METROPOLITAN GOVERNMENT OF NASHVILLE AND DAVIDSON COUNTY

STAFF RECOMMENDATION 905 Manila Avenue August 19, 2015

Application: New construction-infill
District: Greenwood Neighborhood Conservation Zoning Overlay
Council District: 06
Map and Parcel Number: 08204042000
Applicant: Josh Randolph, Aerial Development
Project Lead: Paul Hoffman, paul.hoffman@nashville.gov

Description of Project: The applicant proposes a new single-family home on a vacant lot with limited historic context.

Figure 4. Staff recommends adding windows in these approximate locations marked, to break up the wall space, as well as replacing the transom-style window on the left side with a more vertically-proportioned window.

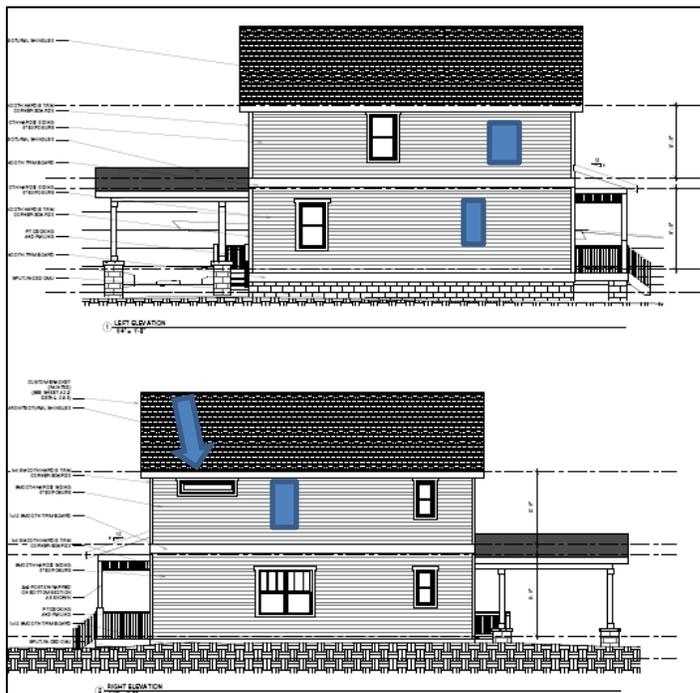
Proportion and Rhythm of Openings: The majority of windows on the proposed building are approximately twice as tall as they are wide, meeting the historic proportion of openings. There are distances of nineteen feet (19'), twenty feet (20') and twenty-seven feet (27') without a window opening on the side elevations. These expanses do not meet the rhythm of openings for historic buildings. Staff recommends the applicant add window openings to each of these elevations. On recent infill projects, the Commission has approved horizontal transom-style windows toward the rear of a side elevation, but not toward the front. Staff recommends the horizontal window on the right side be redesigned to a more traditionally-proportioned window or windows. With these conditions, the project will meet Section II.B.1.g.

1. Window openings are added to the side elevations;
2. The horizontal window on the right side is redesigned to a more traditionally-proportioned window or windows;
3. The finished floor height shall be consistent with the finished floor heights of 909 Manilla, to be verified by MHZC staff in the field;
4. Staff approve the roofing color, and final details, dimensions and materials of windows and doors prior to purchase and installation; and,
5. The HVAC shall be located behind the house or on either side, beyond the mid-point of the house; and Staff approve the roof color and masonry color, dimensions and texture.
